Environmental Impact Report

LDR No. 99-0618
SCH No. 1984030708

SUBJECT: SeaWorld Master Plan Update. SEAWORLD MASTER PLAN UPDATE, MISSION BAY PARK MASTER PLAN UPDATE/LOCAL COASTAL PROGRAM LAND USE PLAN AMENDMENT, and PROGRESS GUIDE AND GENERAL PLAN AMENDMENT to allow an increase of the height limit on the existing 189.4-acre SeaWorld leasehold from 30 feet to a maximum of 160 feet, in order to implement the approved SeaWorld Initiative, Proposition D. The SeaWorld Master Plan Update proposes locations within the theme park area where taller structures could be developed with exhibits, rides, or shows as well as an extensive renovation of the front gate area. One particular area is designated for development as a "Splash-Down" ride. Other structures within the SeaWorld leasehold but outside the theme park proposed to exceed 30 feet in height would include a hotel, an Educational Facility, the Special Events Center expansion, and a parking structure. The project also proposes expansion of the SeaWorld Marina (formerly "Perez Cove" Marina) and would allow for additional future redevelopment throughout the leasehold. The project site is located on SeaWorld Drive, east of Ingraham Str

Figure 4.2-32

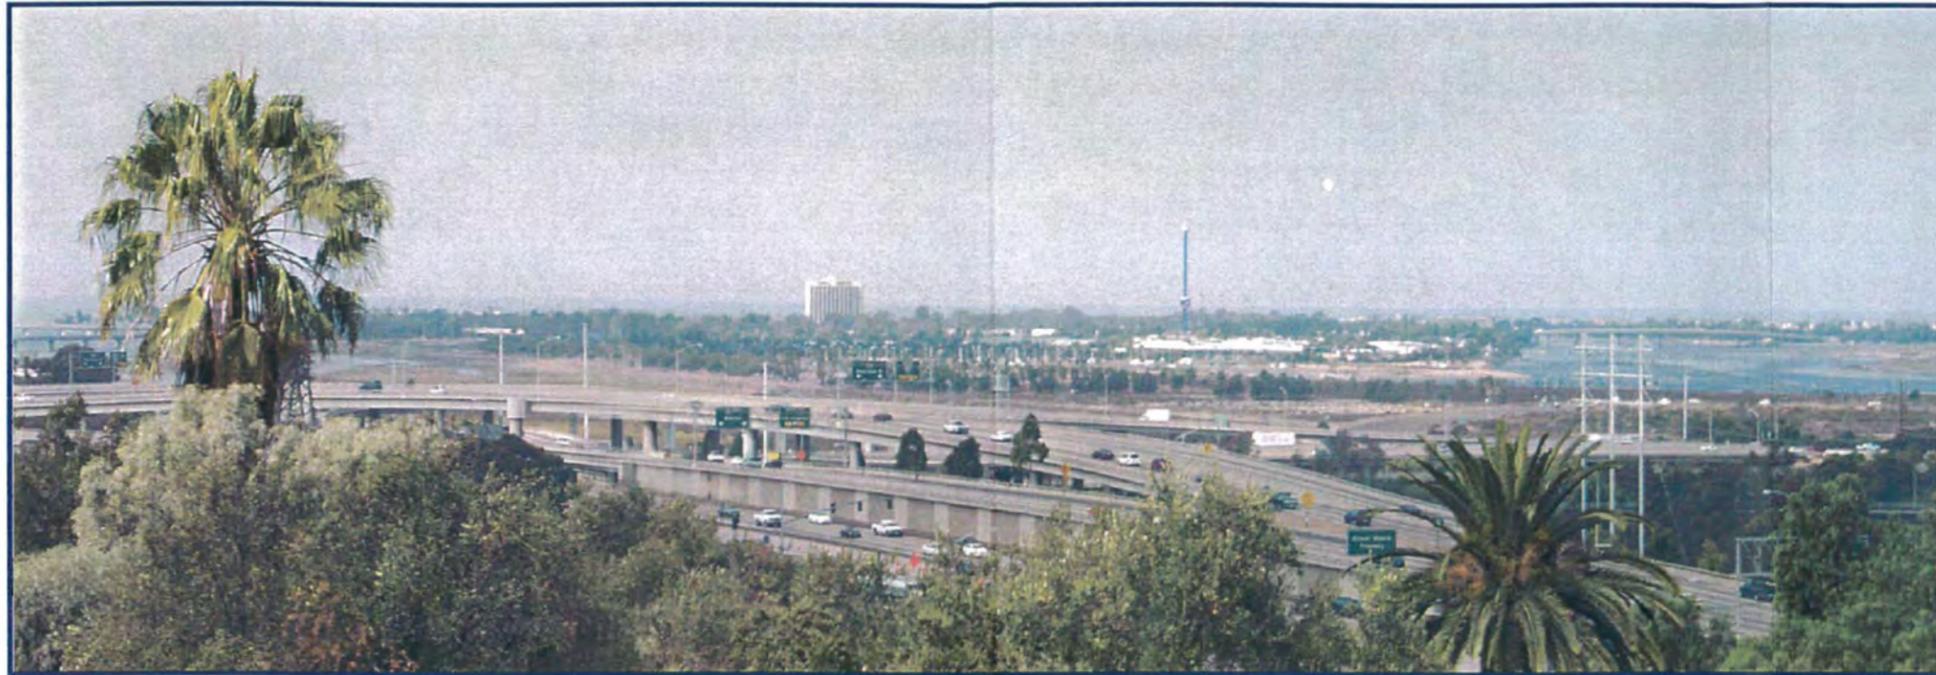
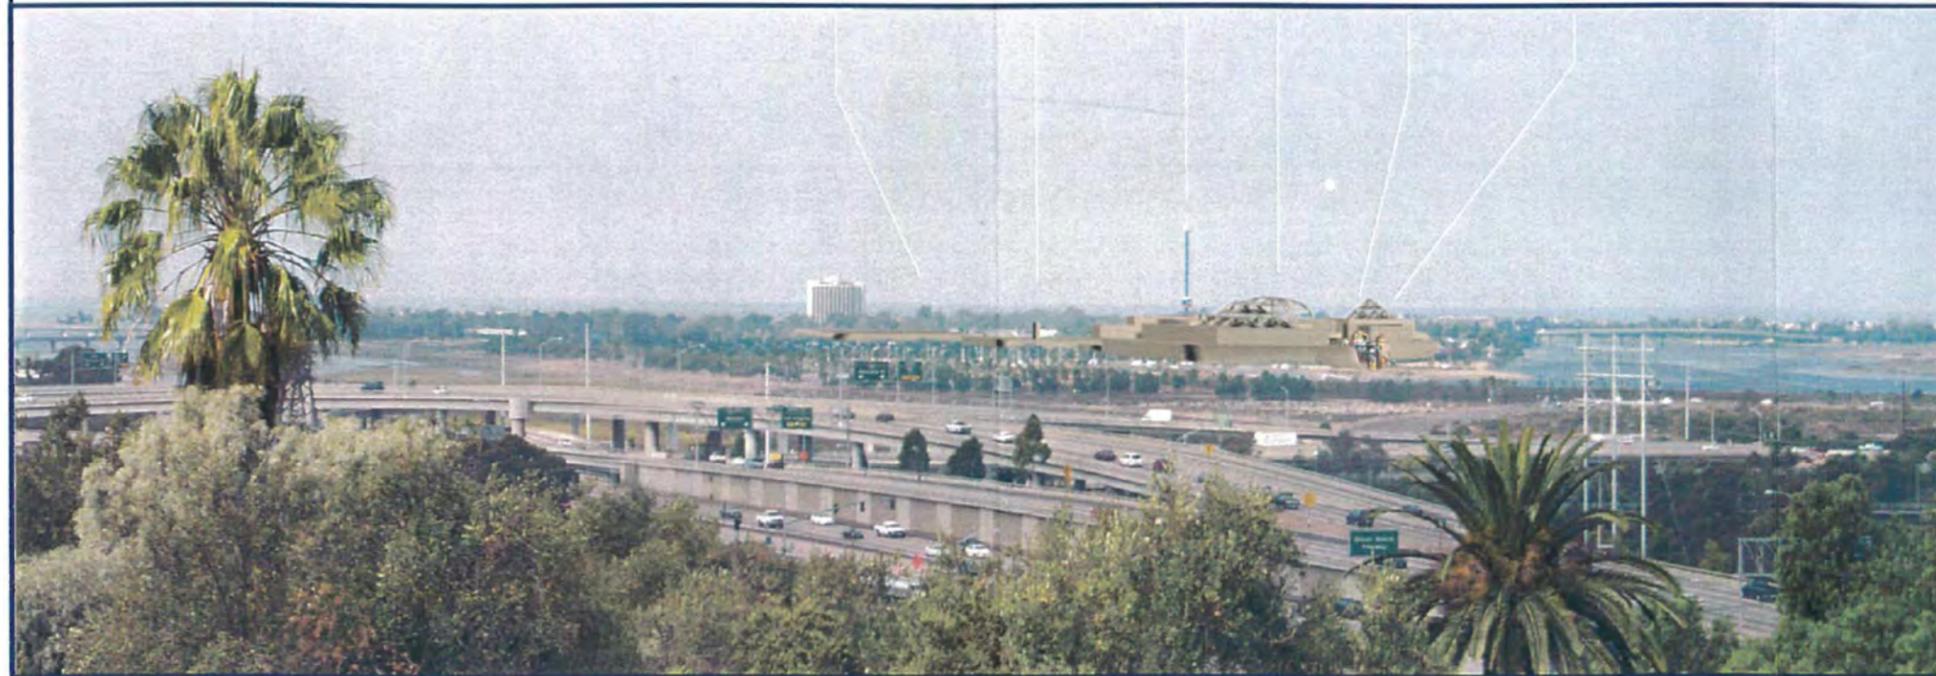
I-600	There are two significant views that would be blocked the most. One is the view from the West Mission Bay Drive Bridge (SWMPU, Draft EIR, KVP-3, Figure 4.2-5). This view is a significant view of Mount Soledad and there is a whole mountain view that would be blocked by the proposed development. (See Exhibit 4, Picture A.) The other is a unique from Clairemont that allows a view of the ocean surf at Dog Beach and Ocean Beach, and a view of the Ocean Beach Pier. (See Exhibit 7 & 8.)	I-600	Visual impacts were addressed in Section 4.2, Neighborhood Characteristics/Aesthetics of the Draft EIR which found significant unmitigable project impacts.
I-601		I-601	See response to comment I-600.
I-602	To reduce view impacts and increase the view thru the project, there are two areas where view corridors with a height limit of 60 feet (or 45 feet) would enhance the public views. (See Exhibit 3.) The concept of view corridors was not considered in the Draft EIR for the Sea World Master Plan Update. While a 60 foot height limit is being proposed here, a 45 foot height limit might be more appropriate for the view corridors to function effectively.	I-602	See response to comment I-599.

I-606	As one can see from the Photosimulation of Maximum Potential Buildout Mass from West Mission Bay Bridge, KVP-3 (SWMPU, Draft EIR, Figure 4.2-32), the potential buildout would totally destroy this view of Mount Soledad from this Bridge. With the proposed Area 2 View Corridor (see Exhibit 3), with a height limit of 60 feet (or 45 feet), a portion of this view would be realized. (See Exhibit 4, Picture B.)	I-606	See response to comment I-600.
I-607		I-607	See response to comment I-599.
I-608	This proposed View Corridor Area 2, would allow a significant portion of the view to be seen from KVP-3 while having minimal impact on the overall project. Only Exhibit Areas J-2, L-2, and C-1 would entirely be affected, and Areas E-2, G-2, and H-2 would be slightly be affected on their perimeters.	I-608	See response to comment I-599.
I-609	Of these, L-2 is a proposed children's area with less need for height than other areas, so the limitation of 60 feet would have little consequences on the development of this area.	I-609	See response to comment I-599.

Figure 4.2-34

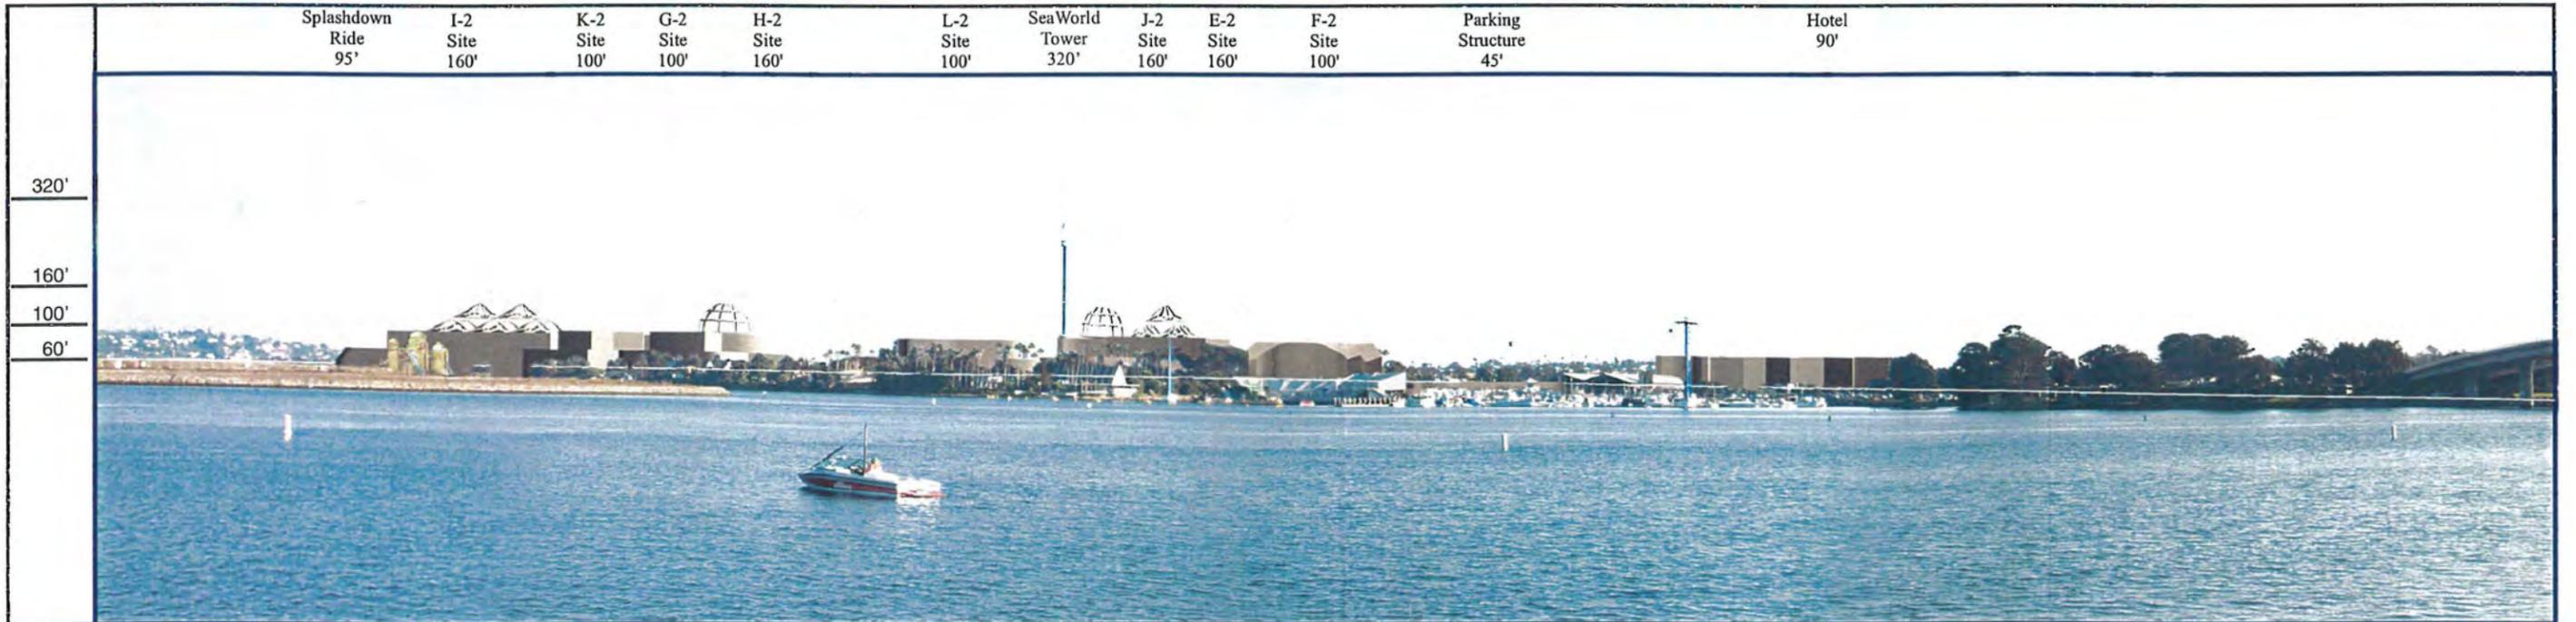
- I-237 See response to comment I-236. SeaWorld has not applied for sixteen permits.
- I-238 Photosimulations were provided from six selected locations around SeaWorld. Photosimulations in Figures 4.2-28 and 4.2-34 in the Draft EIR provide a visual understanding of view impacts to South Shore Park. Photosimulations of the proposed project from Fiesta Island were unnecessary to document the identified significant unmitigable visual impact, because other photosimulations provided a reasonable range of representative key vantage points surrounding SeaWorld. See Figure 4.2-2 in the Draft EIR.
- I-239 SeaWorld signage would be regulated by SeaWorld Master Plan Update Design Guidelines. See also response to comment I-222.

Figure 4.3-1

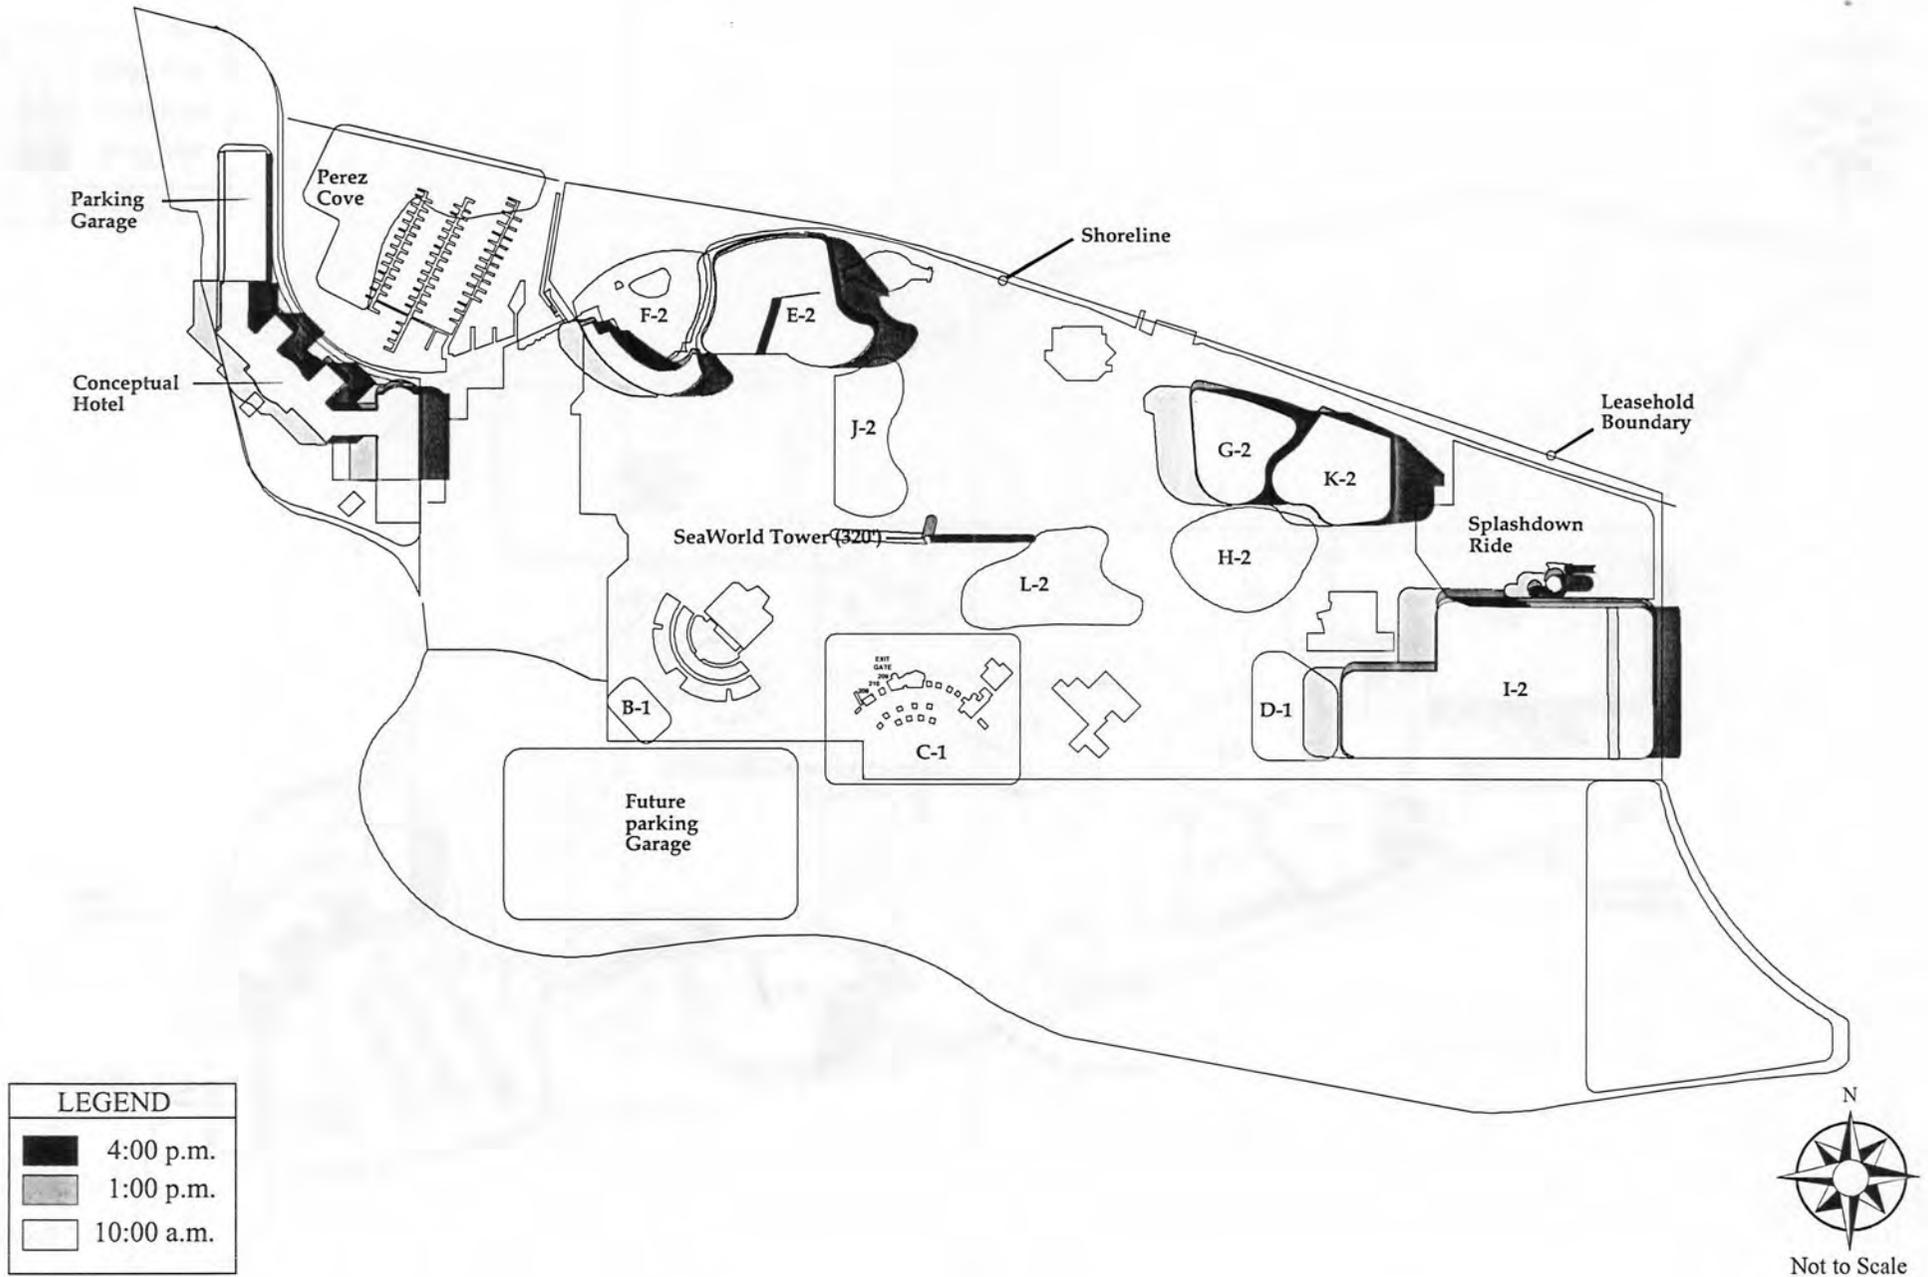
L-108 Section 4.3 analyzes the effects of shading from individual Tier 1 and Tier 2 projects, and Special Projects and specifically references Figures 4.3-1 through 4.3-5 in the Draft EIR which show the effects of shading to the surrounding area. The shading analysis took into consideration the heights and shapes of proposed structures and worse-case maximum development building envelopes for Tier 2 projects and Special Projects.
